Re: State Center Fire Department
Renovation & Addition – Redesign
109 E Main Street
State Center, Iowa 50247

ADDENDUM #03

January 12, 2026

10 PARKING LOT MONOLITHIC PERMEABLE PAVERS

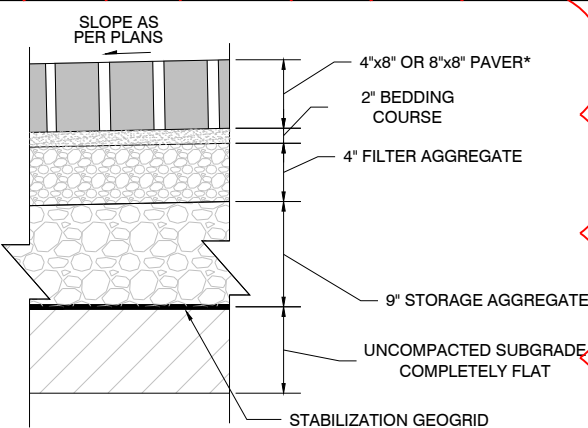
Item #C1: **SHEET C.500, DETAIL 10 – REVIEW PAVER DETAIL**

1. **Revise** detail 10/C.500 to omit sub-paver tile line, see attached.
